NEWMAR CORPORATION WARRANTY DEPARTMENT

RECALL SERVICE BULLETIN

How to Reprogram the HWH Hydraulic Step Module and Update the Hydraulic Plumbing Lines

Recall 16V 768 - On certain motorhomes, the HWH hydraulic entry step controller is not functioning as designed and, in some circumstances, may allow the step to retract unexpectedly with the entry door open.

Preparing for the Software Update

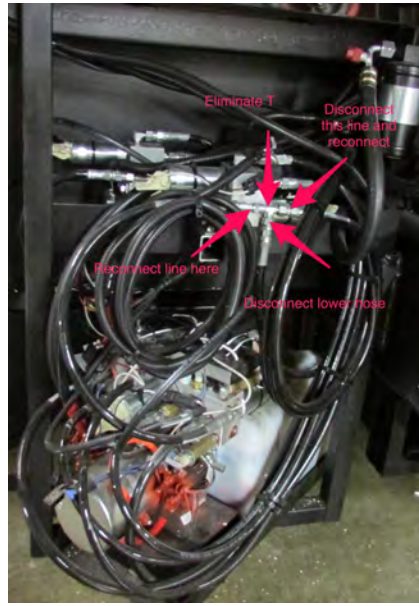
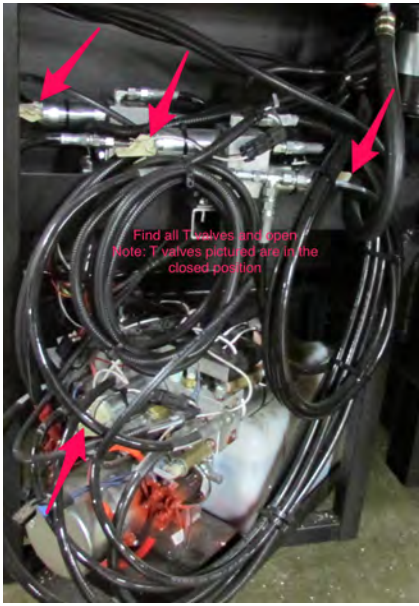
1. Make sure both house and chassis power is being supplied to the coach, and place the key ignition in the run position.
2. Locate the circuit board and power connectors in the upper corner of the first storage bay on the passenger side of the coach.
3. Unplug the two large connectors (one is black and one is tan), along with the smaller grey connector.

Correcting the Hydraulic Plumbing Lines at the Front Lower Manifold

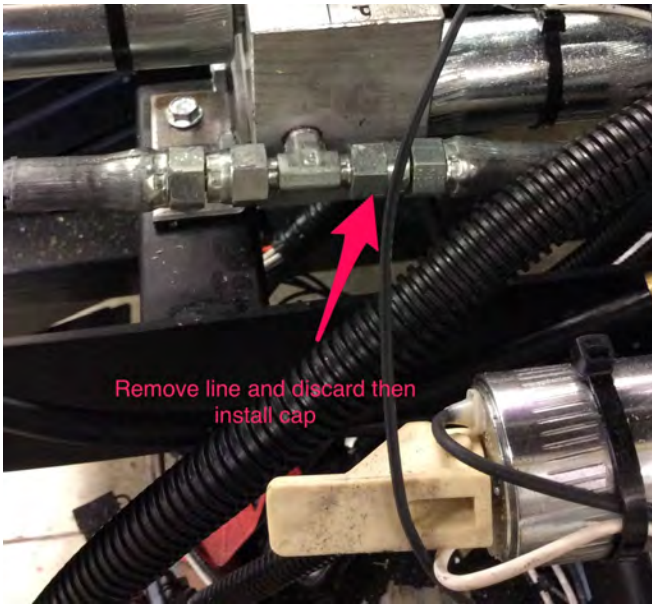
6. Open the generator door to access the HWH pump located on the passenger side of the coach.
7. Open all T-valves on the pump and manifolds to relieve the pressure in the lines.
8. You may need to cut the lower two wire zip ties on the bundle of hydraulic hoses. This bundle connects to the pump and may need to be loosened for the rest of the repair.
9. Remove the two hydraulic hoses located on the right side and bottom of the T-connection, which is on the front of the lower manifold.
10. Remove the T-connector.
11. Reconnect the hose from the right side of the connector. Leave the bottom hose loose.

Correcting the Hydraulic Plumbing Lines at the Rear Manifold

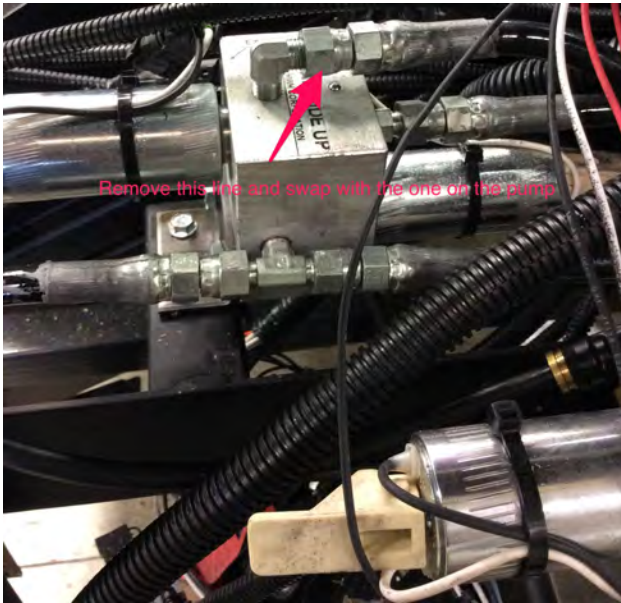
12. From the rear manifold, disconnect the loose hose, and install a cap.
13. Discard the removed hose.

14. From the top of the rear manifold, remove the hose from the elbow connection.
